1 Products affected

Product Change Notification					PCN CMFx		
owner	creation date	release date	released by	change order no	rev	page	D10-037-610
huberth	18.06.2019	09.07.2019	limachcl	2017851	A	1 of 2

Old appearance of markings	New appearance of markings

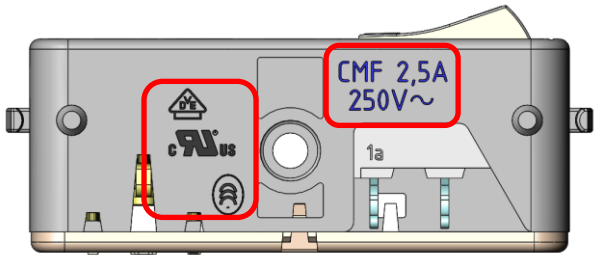
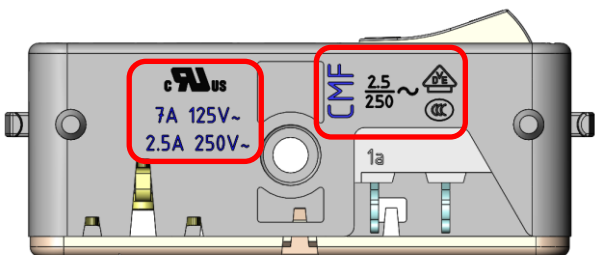
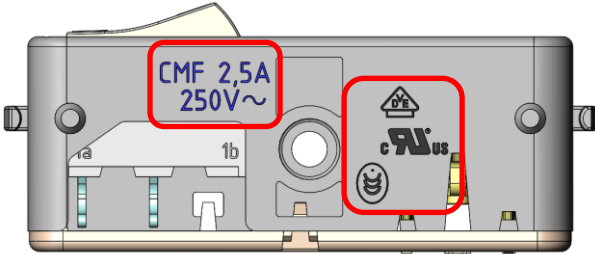
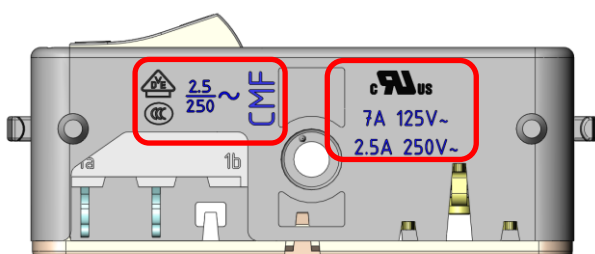
- Change of markings
- Change of quick connect terminal

- Standard update to UL/CSA 60320-1
- Quick connect terminal too close to the socket wall (Only applicable for part numbers CMF2.1015.11 and CMF2.1015.12)

Old quick connect terminal 4.8x0.8	New quick connect terminal 4.8x0.8

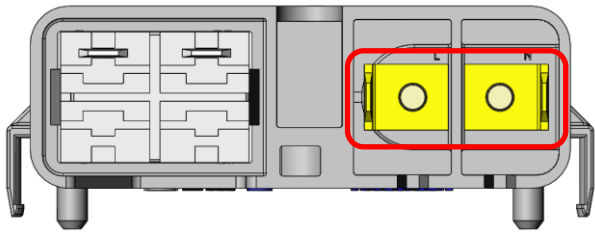
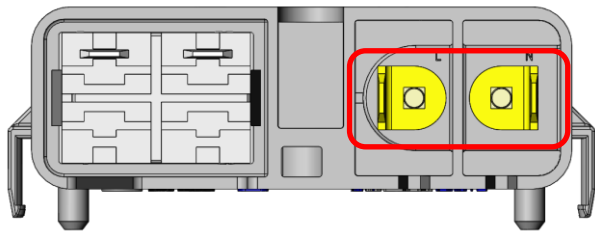
Only articles CMF2.1015.11 and CMF2.1015.12 are affected by this
